October 21, 2019

Antrim Wind Energy Project Photographic Log

Antrim Wind Energy Project
Antrim, New Hampshire

As-Built Survey

Photo 1: Image taken on 8/2/2019. Image showing the base of the rock slope adjacent to wetland AN-41 was stabilized with straw mulch per NHDES recommendations during 7/26/2019 inspection.

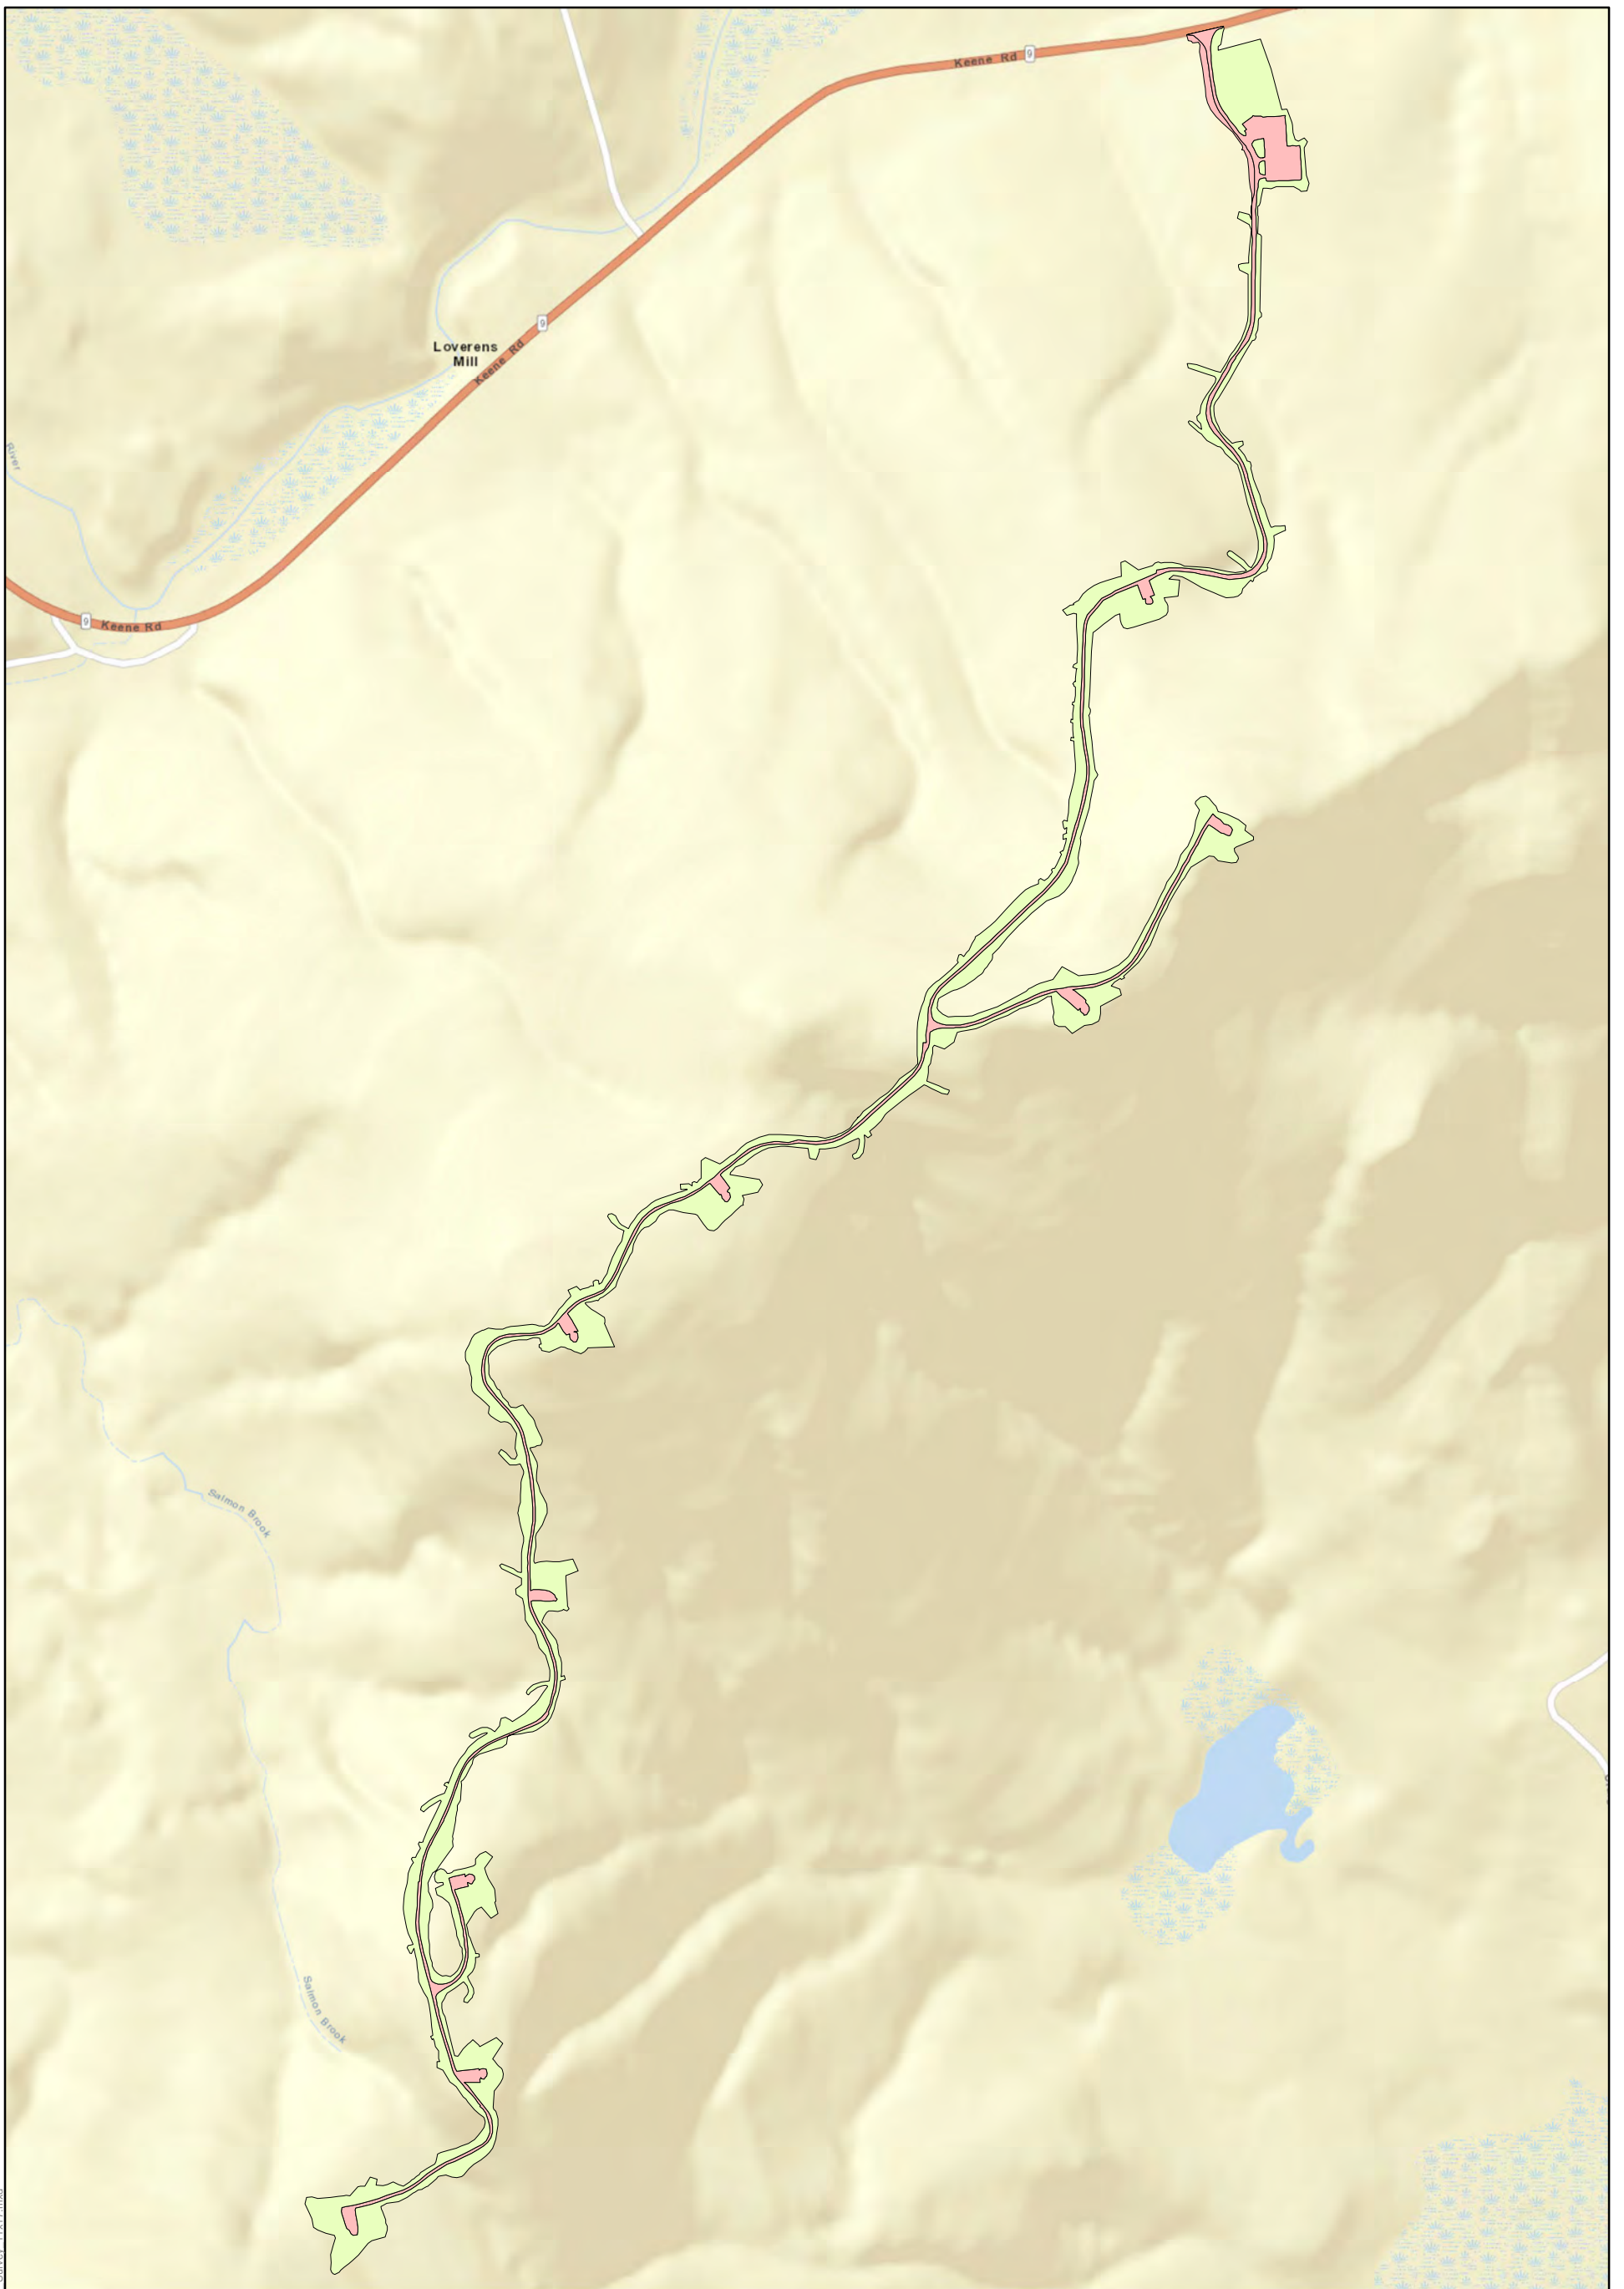
- 1. Please install appropriate permanent stabilization BMP's at the base of the rock slope adjacent to wetland AN-41 and remove any accumulated sediment which has been deposited outside of the approved impact area. NHDES believes this can be accomplished within 20 days. Please submit photos documenting compliance was achieved. NHDES believes this can be accomplished within 7 days of completing the work.*

1. See the attached photo log which provides documentation that temporary stabilization in the form of straw mulch and seeding has been installed in the permitted wetland impact area and at the toe of the rock slope adjacent to AN-41. During the site visit on July 26, 2019, it was recommended and agreed to by NHDES that the sediment would be mulched to be stabilized and the area would be monitored for revegetation. This area was stabilized within one week of the NHDES site visit as demonstrated in the inspection report completed on August 2, 2019.

Photo 2: Image taken on 8/28/2019. Image showing the base of the rock slope adjacent to wetland AN-41 was hydroseeded prior to the inspection on 8/28/2019.

Photo 3: Image taken on 9/26/2019. Image showing revegetation progress at the base of the rock slope adjacent to wetland AN-41.

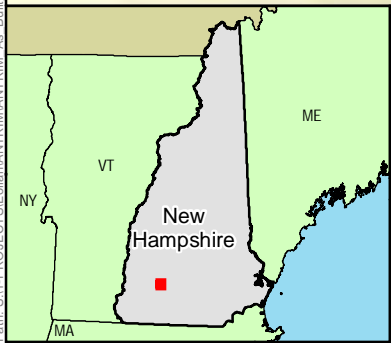
- 2. Within 20 days of the date of this letter provide DES with a plan for review, to re-establish the hydrology through culvert SD-26 to alleviate perched conditions at the inlet.*

2. The earthwork contractor has added fill and small diameter blast rock to raise the elevation of the ground upstream of the inlet, alleviating the perched condition of the culvert inlet. See attached photo log for documentation. This work had been completed as a response to comments made by NHDES staff during the July 26, 2019, site inspection and was completed prior to receipt of the September 10, 2019, letter requesting remedial actions.

Photo 4: Image taken on 9/12/2019. Image showing fill and small diameter blast rock has been added to raise the elevation of the ground upstream of the inlet at culvert SD-26, alleviating the perched condition of the culvert inlet. Corrective actions to address perched conditions were taken prior to receipt of the letter from NHDES dated 9/10/2019.
